Access Compliance Report

Public Rights-of-Way

Intersection ID: 30240	Main Street: OLD_PLANK_RD	Cross Street: MCGINN GROVE_DR	Location:	N
ADA ID: 88DB6DE997C8	Ramp Type: Perp	Initial Pass/Fail: Fail	Overall Compliance: No	Severity Score: 33.75
Codes/Mitigation Info/Possible Solution		Field Measurements/Component Compliance

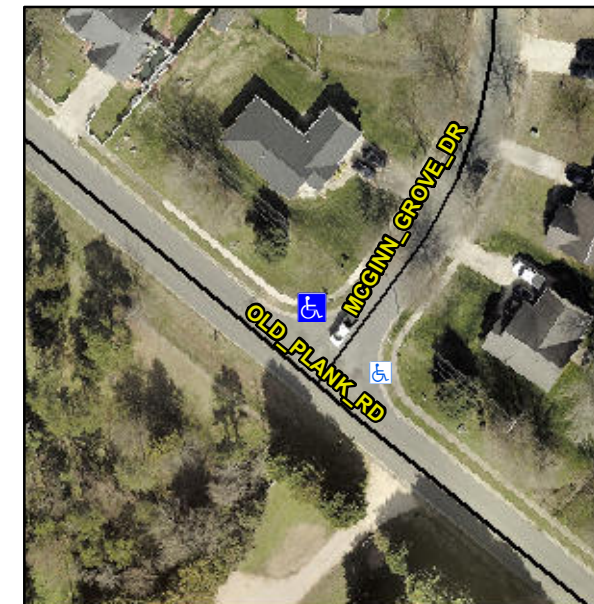
Not Found, R304.5.1, R304.2.2, R304.5.3

Compliance	Description	Data	Compliance	Description	Data
N/A	Ramp Length (in)	49.5	No	Ramp Slope (%)	11.9
No	Ramp Width (in)	47.0	No	Ramp XSlope (%)	5.3
N/A	Flare Type LT	N/A	N/A	Flare Type RT	N/A
N/A	Flare Slope LT (%)	N/A	N/A	Flare Slope RT (%)	N/A
N/A	Flare Traversable LT?	N/A	N/A	Flare Traversable RT?	N/A
N/A	Landing Length (in)	N/A	N/A	DWS Provided?	N/A
N/A	Landing Width (in)	N/A	N/A	DWS Contrast?	N/A
N/A	Landing Slope (%)	N/A	N/A	DWS Length (in)	N/A
N/A	Landing X Slope (%)	N/A	N/A	DWS Full Width?	N/A
N/A	Landing Curb? (Y/N)	N/A	N/A	DWS Offset (in)	N/A
N/A	Shared Landing?	N/A			
N/A	Gutter Ponding?	N/A	N/A	Gutter Slope (%)	N/A
N/A	Gutter Lip Ht (in)	N/A	N/A	Gutter X Slope (%)	N/A
N/A	Painted X Walk1?	No	N/A	Painted X Walk2?	N/A
	X Walk 1 Direction	To SE		X Walk 2 Direction	N/A
N/A	X Walk 1 Width (in)	N/A	N/A	X Walk 2 Width (in)	N/A
	X Walk 1 Slope (%)	0.9		X Walk 2 Slope (%)	N/A
	X Walk 1 X Slope (%)	8.1		X Walk 2 X Slope (%)	N/A

Remove & Replace Entire Ramp.
